**City of Gainesville  
Department of Doing  
Planning Division**

**SUMMARY OF CITY COMMISSION ACTION ON  
PETITION DB-18-17 SUB OAKS PRESERVE CLUSTER SUBDIVISION**

**PROJECT NAME AND NUMBER:** Oaks Preserve Cluster Subdivision, Petition DB-18-17 SUB.

**Exhibit A: – Amended Design Plat with Bike Trail**

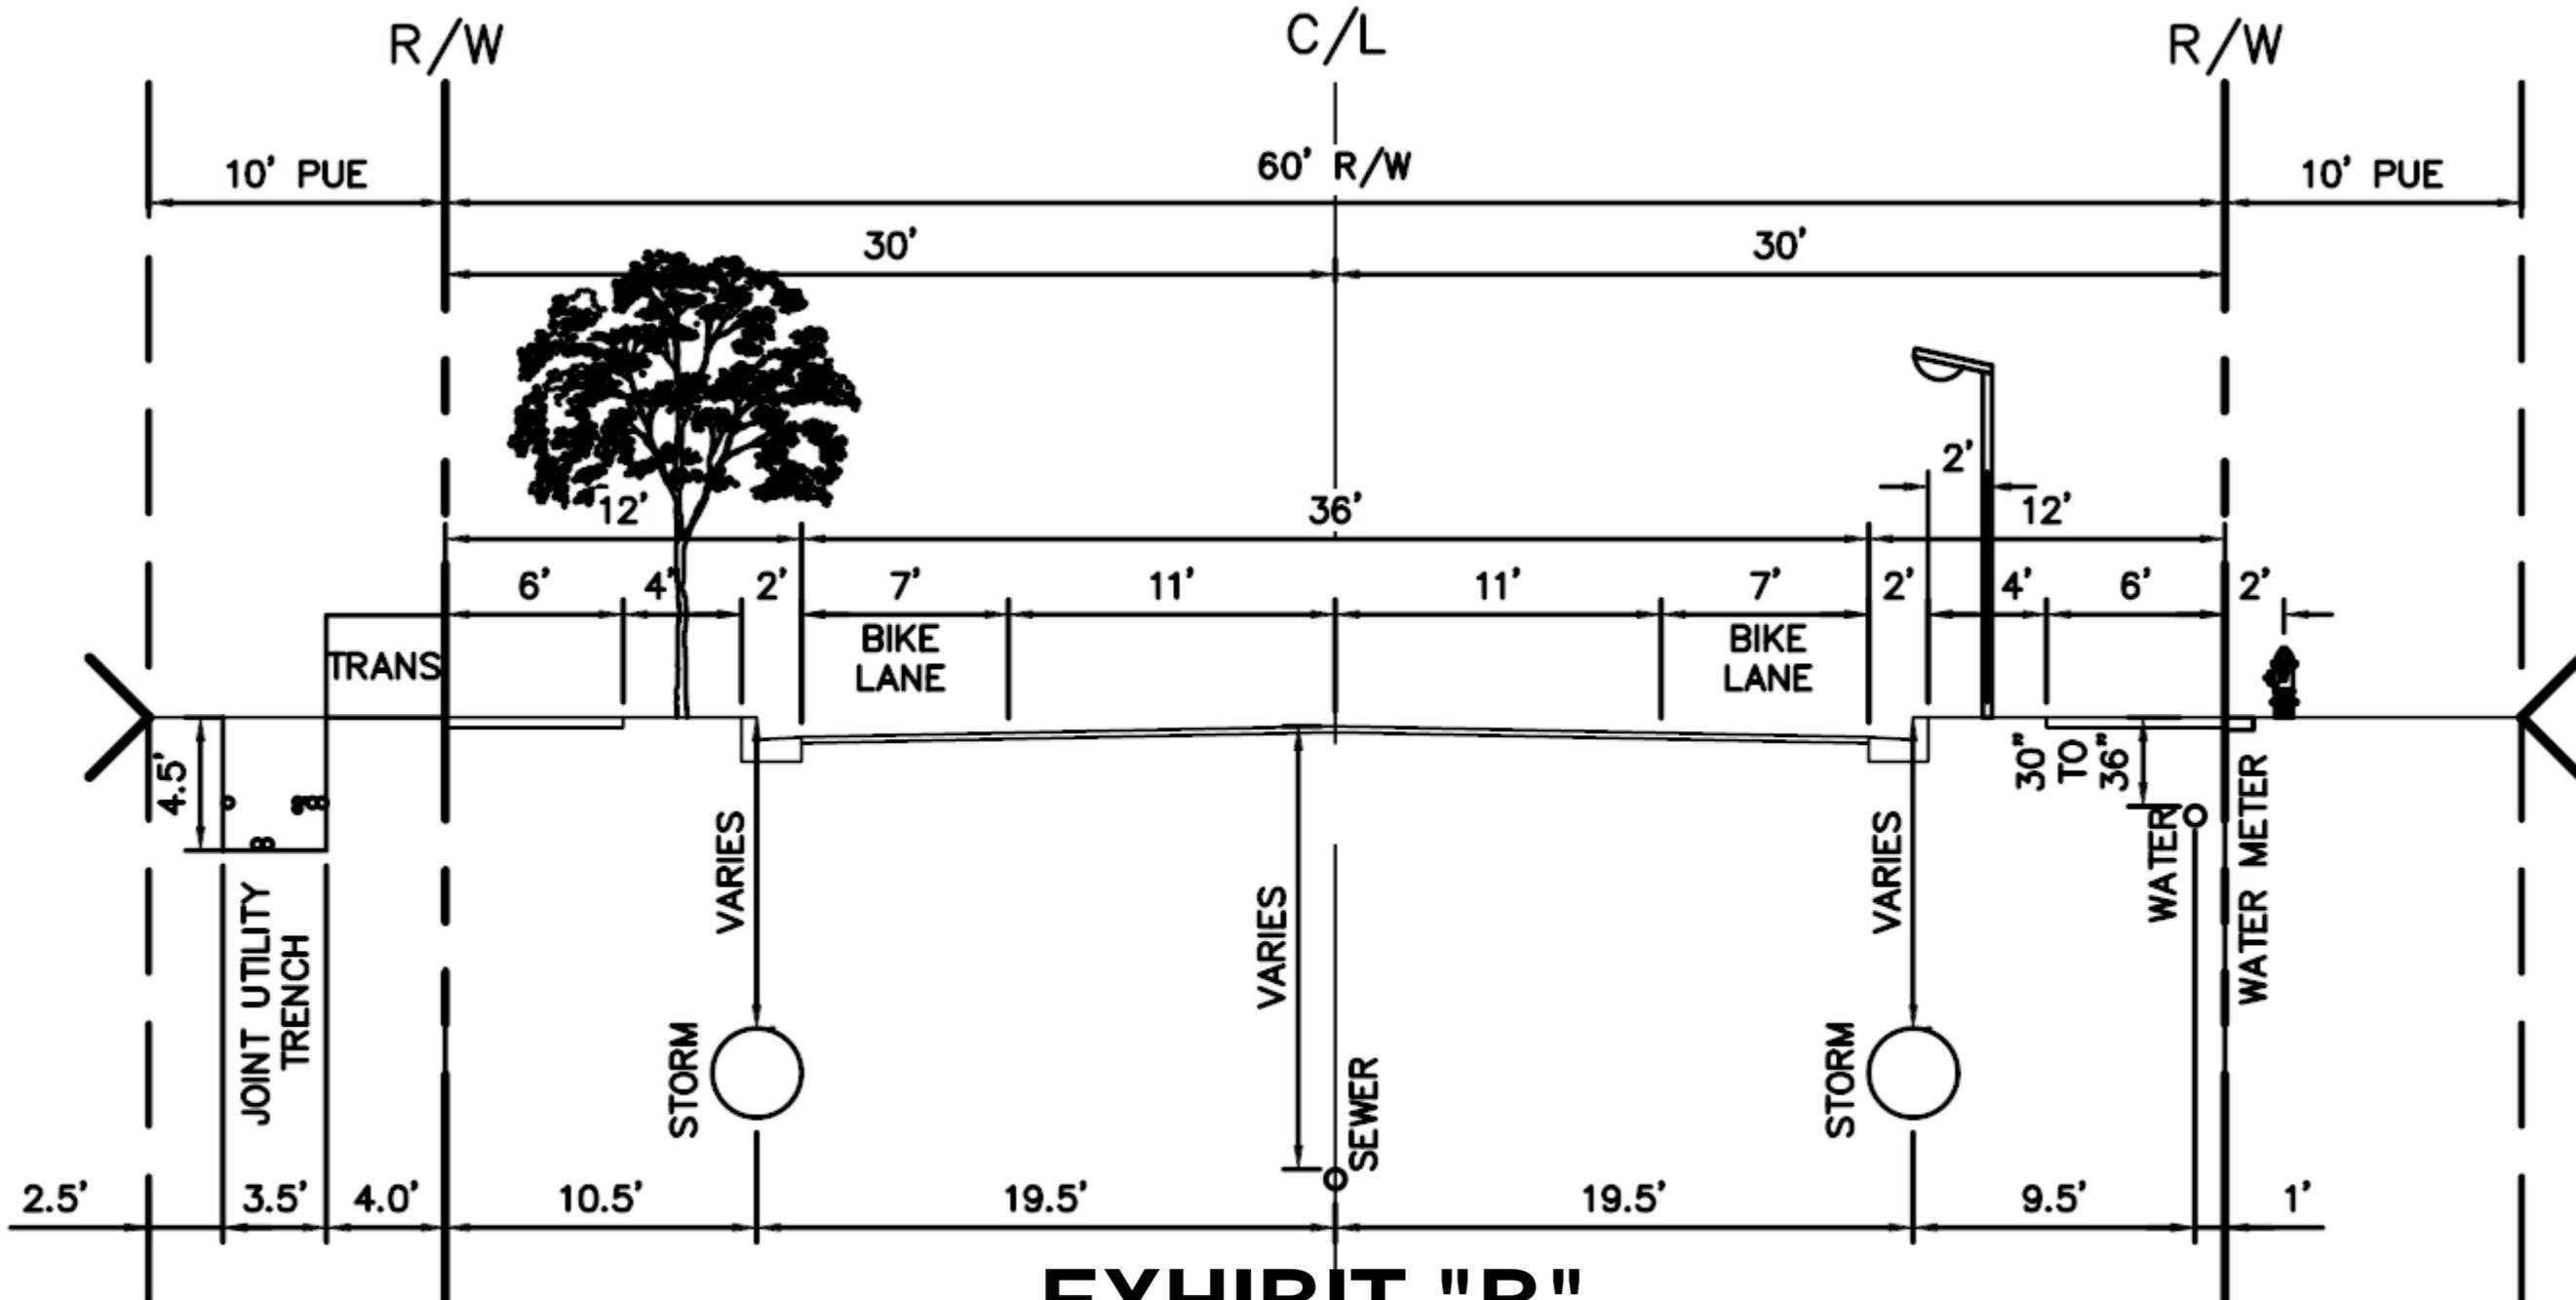
- 1. The north/south trail shall be reconfigured to run as an independent route and shall not be designed as a shared path within the proposed rights-of-way. The trail shall be designed as a 10-foot wide multi-use trail and shall be routed at the back of lots.**

- 3. Prior to approval by the City Commission, the subdivision shall be designed to show a second or third phase with a third approved external connection to the closest officially paved roadway.**

*The north/south trail is designed as a separate 15-foot wide route outside the main roadway network. Parts of the trail run to the rear of lots and around the environmentally sensitive area at the southern end of the development, as depicted in Exhibit "A" and "C". The trail crosses the road network at two locations. The trail will be constructed together with the specific phase in which it is located. Details of the trail will be reviewed and approved during Construction Drawing review and will receive final approval by the City*

*The subdivision is planned to be implemented in three phases as depicted in Exhibit A. Approval of Phase II, or any phase after phase I, shall include construction of a 20-foot wide emergency access route within or along SW 57<sup>th</sup> Avenue. The route shall be designed to comply with or exceed the minimum Emergency Access Fire Rescue Route standards required by the Gainesville Fire Safety Department. Details of the route shall be included with Construction Drawing plans and shall require approval by the City Commission during review of Final Plat.*

# EXHIBIT "B"

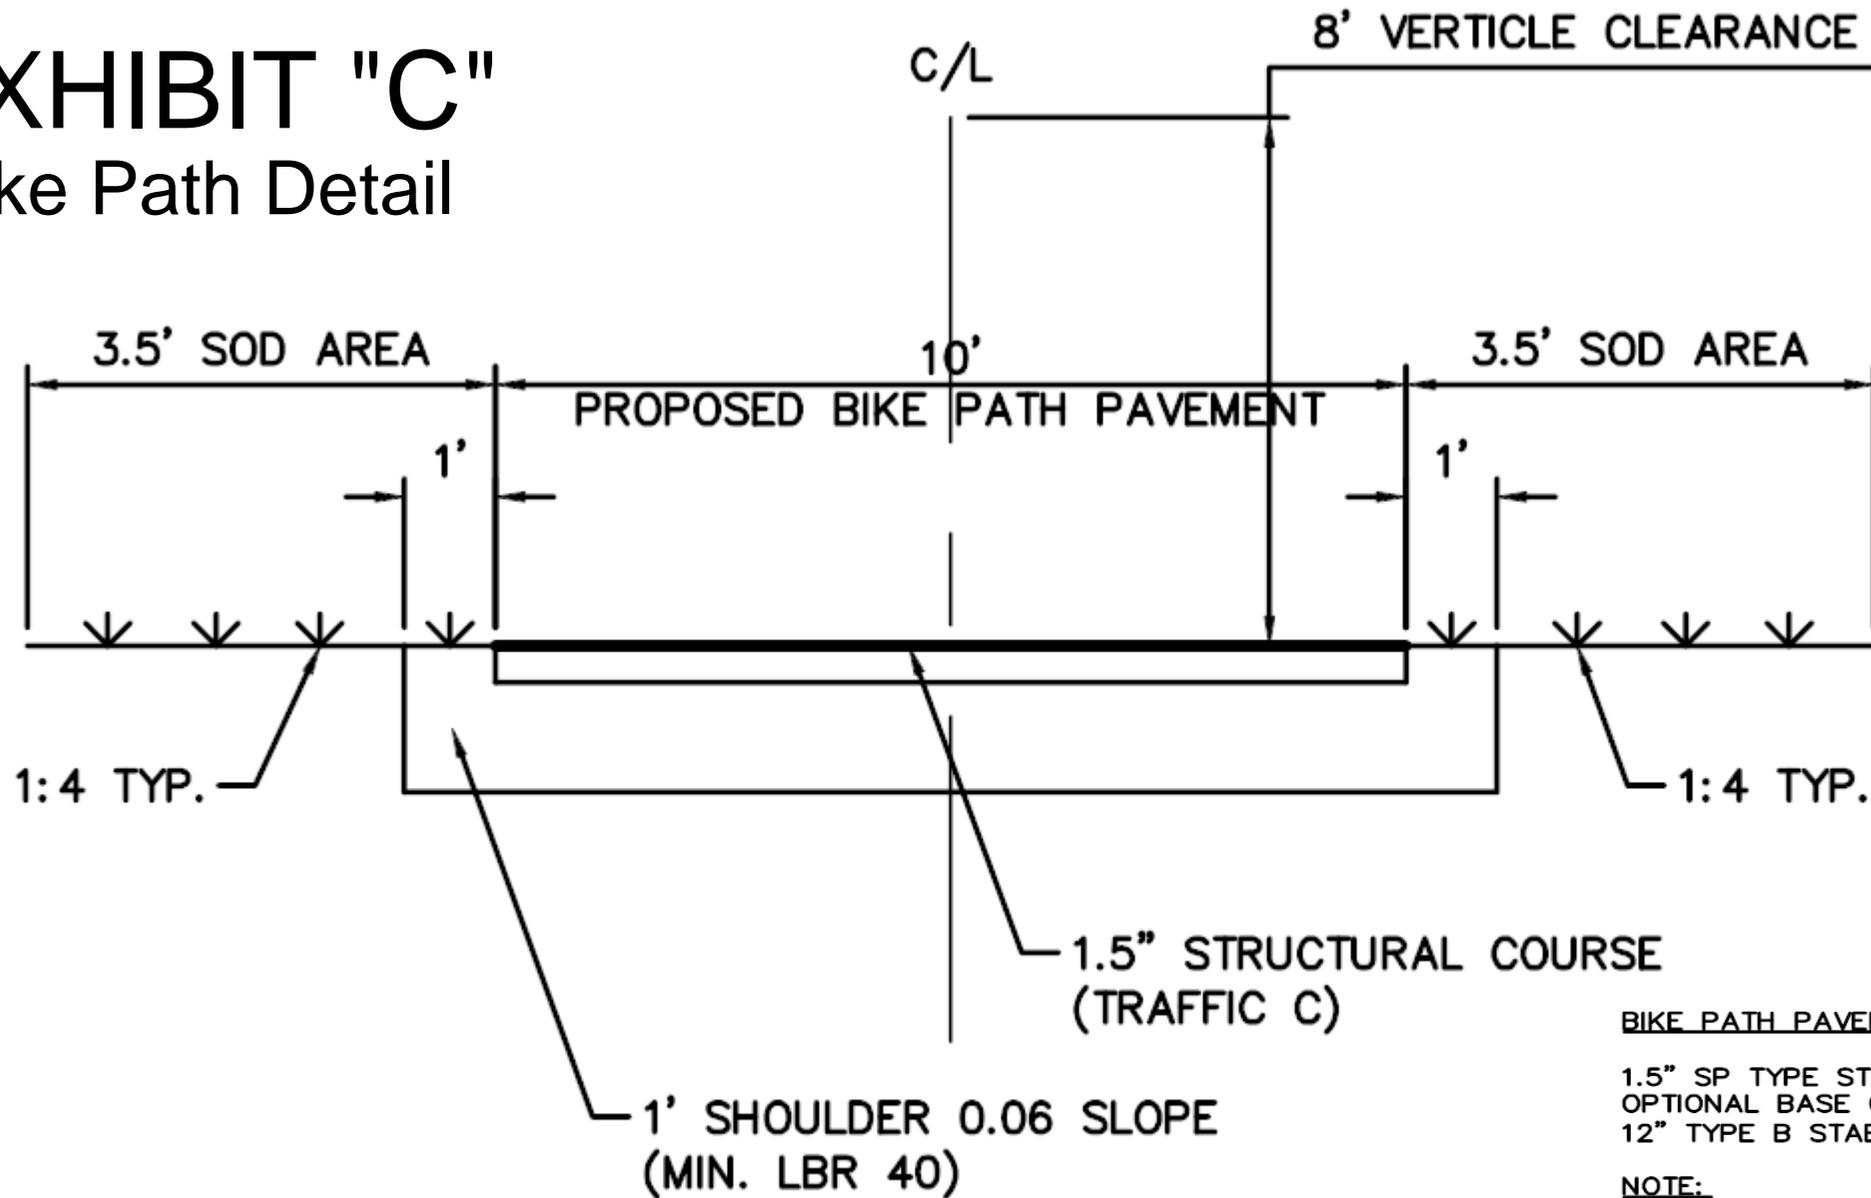
- 5. A 7-foot wide buffered bike lane shall be constructed on both sides of Road "Q"; the design shall be resubmitted to the City Commission for final approval.**

*A new design for Road "Q" is submitted showing a 7-foot wide bike lane on both sides of the road. Both the east and west ends of the road have been designed to accommodate future connections without impacting proposed lots. Additional details are depicted in Exhibit "B".*
